RESPONSE TO SUBMISSIONS

EXPLORATORY WORKS MODIFICATION 1

Snowy 2.0 Exploratory Works Modification 1

Response to Submissions Report

Snowy 2.0
Exploratory Works EIS
Modification 1
Figure 3.6

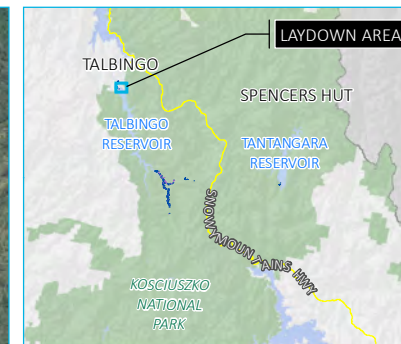
- The detail identified in Figure 3.6 does not clearly indicate the distinction between vehicle and pedestrian access to sites. Some access identified on the map is not currently used or has been closed and rehabilitated.
- Section 3.2.9 identifies that, “Snowy Hydro proposes to retain the option of installing monitoring equipment in any of the boreholes for ongoing groundwater monitoring purposes. This may occur sometime in the future following the decommissioning activities.”

- Clarification on the detail in Figure 3.6 is provided with clear documentation of the requirements for use and maintenance of access tracks in KNP. The impact of any clearing of vegetation along rehabilitated tracks is to be quantified.
- A set time frame for all activities and continuing access to the works is to be provided.
- All rehabilitation is to be incorporated into the Exploratory Work Rehabilitation Plan (yet to be developed) as per Condition of Approval 58.

Snowy 2.0
Exploratory Works EIS
Modification 1
Figure 4.4

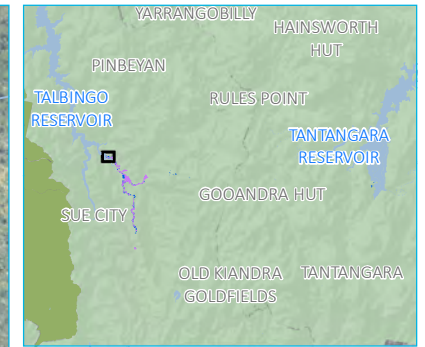
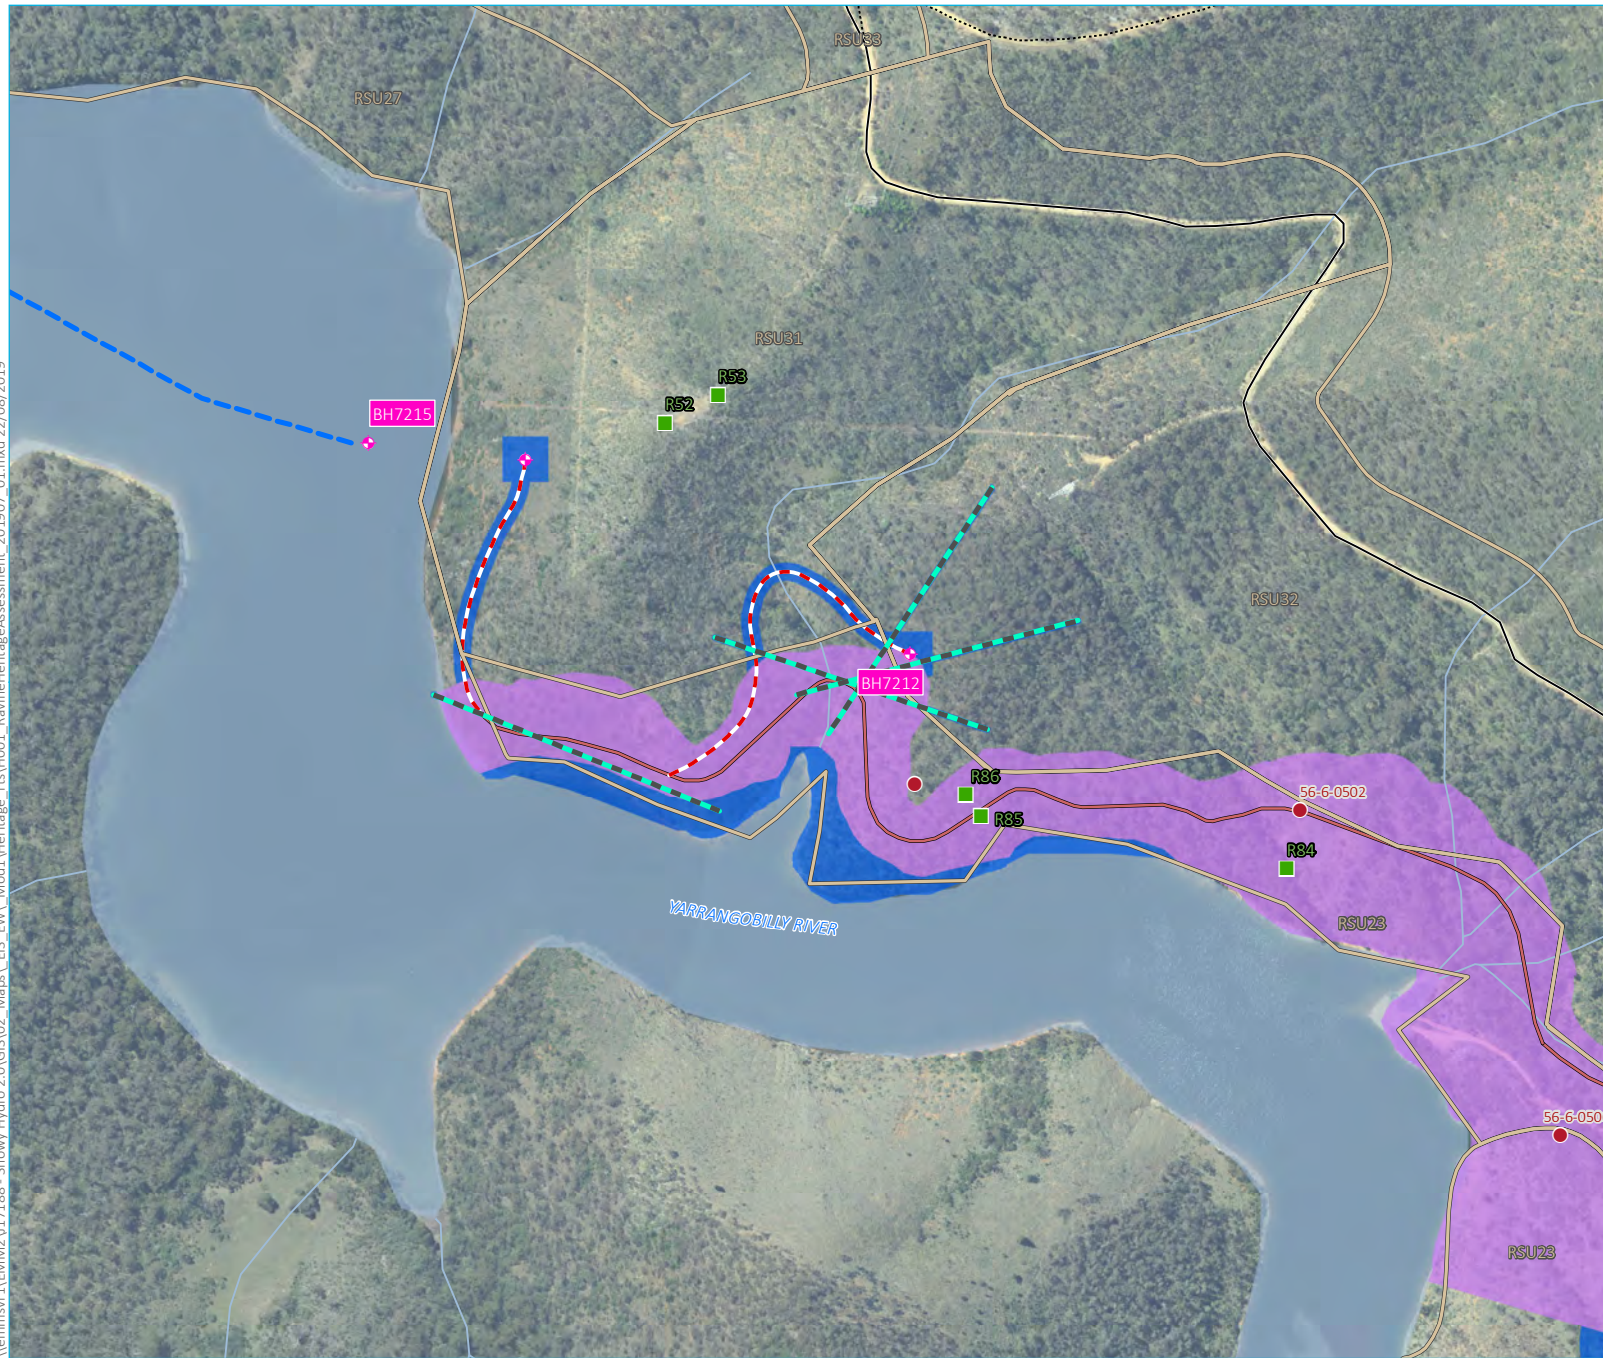
- The Aboriginal and Historic Heritage assessment as outlined in Section 6.2 and shown in Figures 6.3 – 6.6 does not include work associated with BH7201 & 7212 and associated access tracks or geophysical surveys.
- Please note a separate response is to be provided by the Heritage Division of DPC in regard to Heritage Council responsibilities.

- Clarification on the assessment undertaken for activity around Talbingo Reservoir associated with BH7201 & 7212 is to be provided.

Snowy Hydro notes that the Aboriginal and historical sites that are potentially affected by the proposed modification footprint are documented in Table 6.4 and shown on Figure 6.3 to Figure 6.6. The works near Talbingo was surveyed within survey units RSU23 and RSU32 but do not have the potential to affect Aboriginal or historical heritage items. As no heritage impacts will be in the vicinity of the works associated with BH7201 and BH7212, they were not included in Table 6.4 and a figure was not prepared.

Notwithstanding the above, the following information provided in Table 4.2 and Figure 4.4 demonstrates that no Aboriginal or historical heritage sites will be impacted by the proposed works relating to BH7201 and BH7212.
